# UNITED STATES PATENT AND TRADEMARK OFFICE

<b>Office Action Summary</b>	<b>Application No.</b> 10/526,170	<b>Applicant(s)</b> SATOJI ET AL.
	<b>Examiner</b> JUSTIN KRAUSE	<b>Art Unit</b> 3656

**DETAILED ACTION**

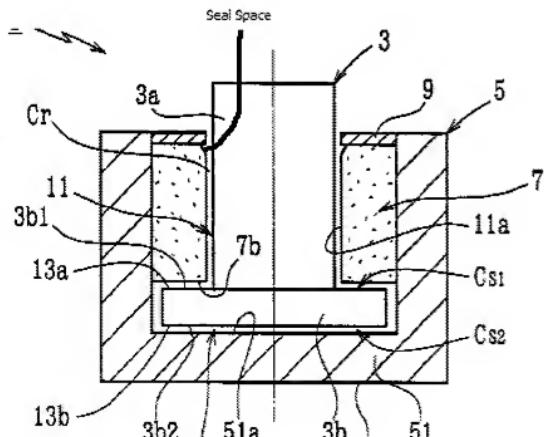
Applicant argues that one cannot make the seal portion of because the device could not be assembled. The device as claimed is considered the device in its final form. As is discussed above, elements may be made integral to one another via manufacturing processes. Thus one of ordinary skill would have found it obvious to make the seal ring integral to the housing after assembly.

With regard to the argument that Mori does not identify a seal space, the figure illustrated below discloses an identifiable seal space.
